ADDENDUM #1

PROJECT: SLOAN CREEK CONNECTOR TRAIL

PROJECT: FAIRVIEW PEDESTRIAN BRIDGE
 OWNER: CITY OF FAIRVIEW
 ADDRESS: FAIRVIEW, TX

CONTRACTOR: _____
 DESCRIPTION: 10' X 150' CORNERSTONE PEDESTRIAN BRIDGE

JOB NO: 18431P
 SHEET: 1 OF 3

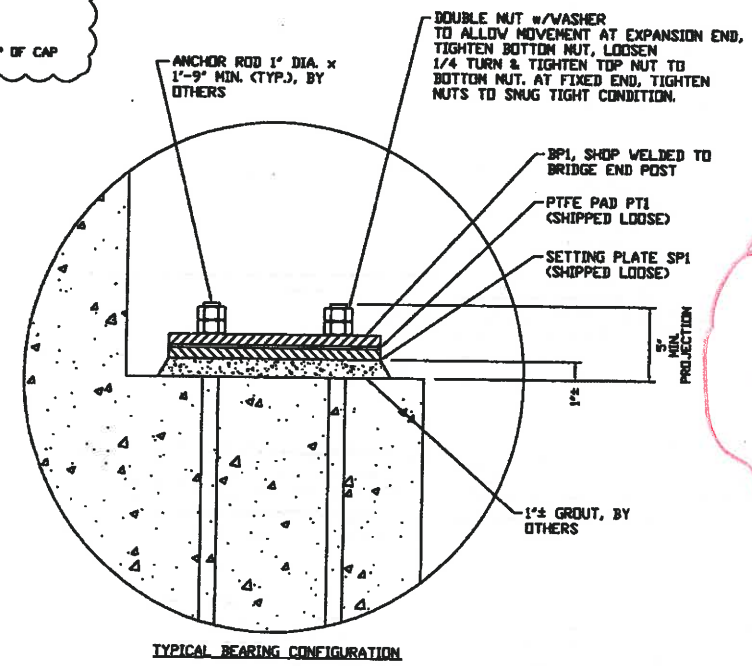
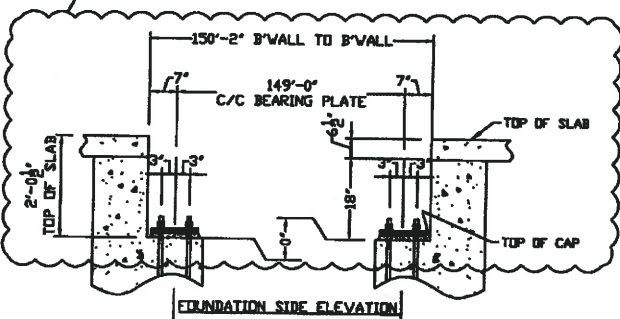
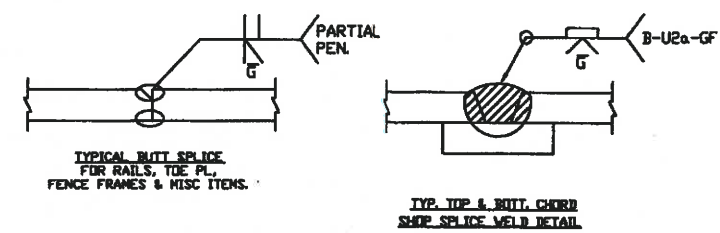
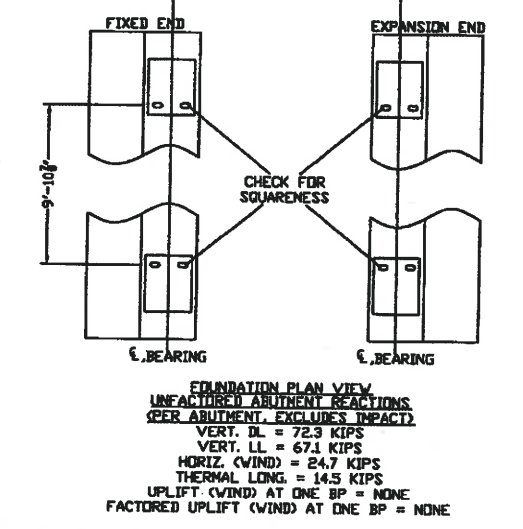
NOTE TO ERECTOR:
 EXPANSION END TO BE LOCATED AT EXISTING ABUTMENT

C	UPDATED ABUTMENT DETAILS	SAR 5/2/18	AF 5/2/18
B	REDUCED BACKWALL HEIGHT	SAR 4/17/18	AF 4/17/18
A	FOR APPROVAL	SAR 3/15/18	MRP 3/16/18

SHEET: 2 OF 3

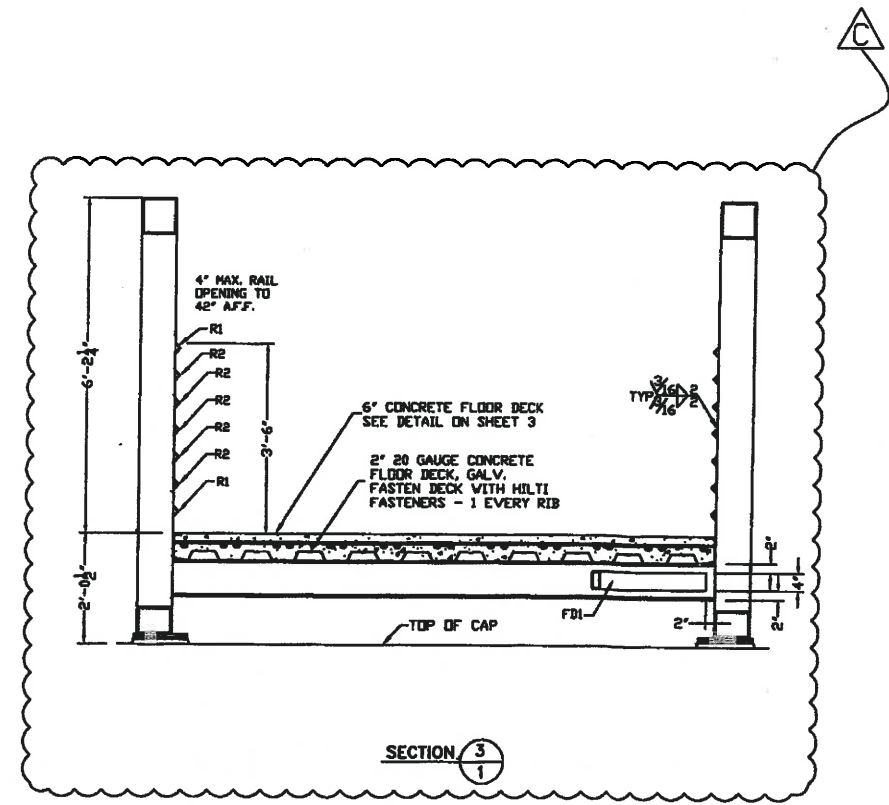
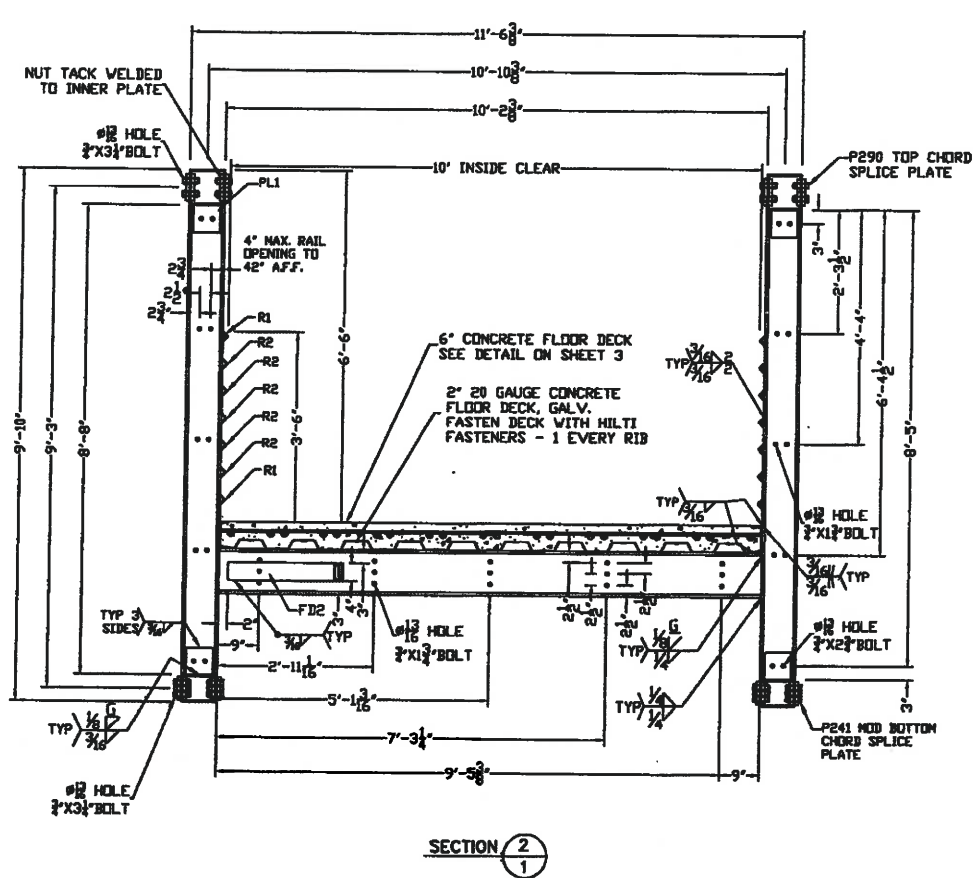
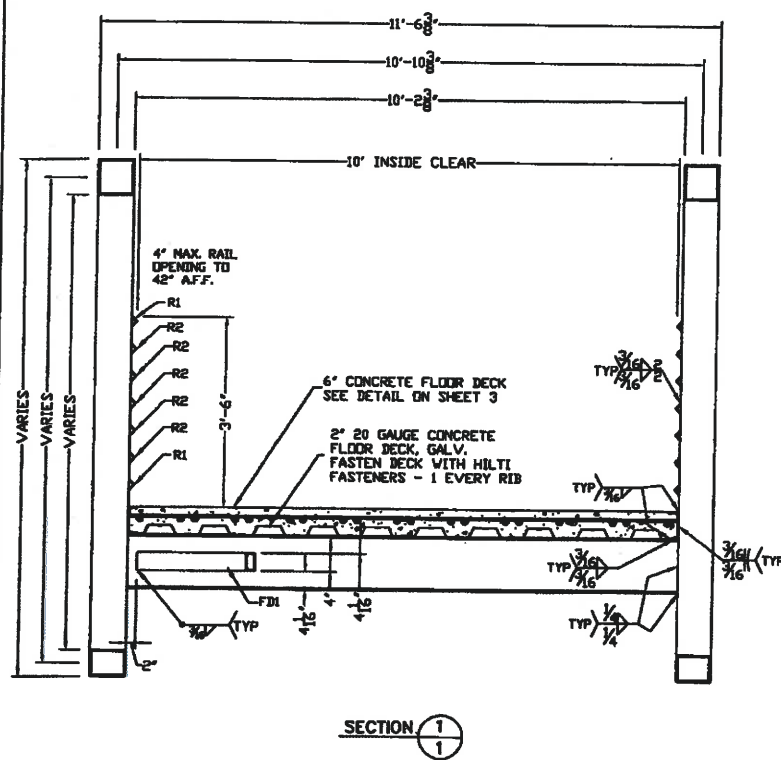
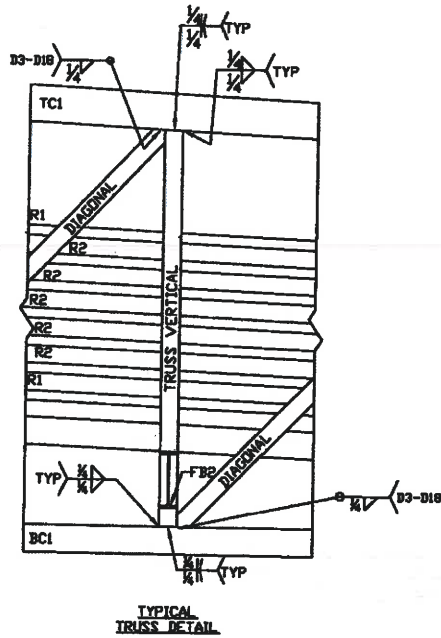
C	END TRUSS SECTION ADDED	SAR 5/2/18	# 5/2/18
B	UPDATED BACKWALL HEIGHT	SAR 4/17/18	# 4/17/18
A	FOR APPROVAL	SAR 3/15/18	# 3/16/18
REV	DESCRIPTION	BY/DATE	CHECKED BY
